Subarunet Announcement

Date: August 4, 2016 (Revised 8/8/16 for updated labor operation number on page 3)

Subject: Updated inflator information for 2003 MY Legacy, Outback, and Baja related to Takata Recalls: WQR-53, TKA-16, TKB-16, and TKC-16

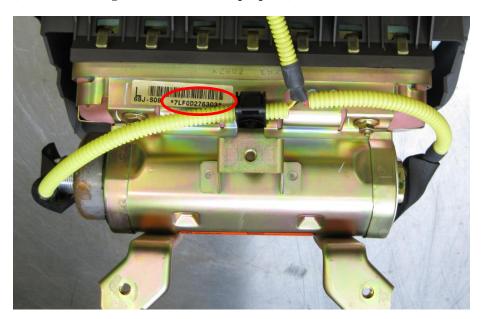
These early production 2003 MY vehicles (77,000) were equipped with inflators produced by Autoliv. Autoliv produced inflators do not contain ammonium nitrate and are not included in any Takata inflator recall.

These Autoliv inflators do not require replacement as part of any Subaru airbag recall.

All related campaign information will be updated shortly to include an inspection portion applicable exclusively to 2003 MY Legacy, Outback and Baja. The inspection involves lowering of the glovebox to provide enough access to visually inspect the label on the airbag module. Labels containing "7LF" identify Autoliv modules and those with "7LG" identify Takata as shown in the photos below. If the vehicle in question is identified as having an Autoliv airbag inflator installed, **STOP and note the 11-digit serial number only** as no further action is required other than refitting the glove box. Only vehicles with Takata airbag inflators are affected by this campaign.
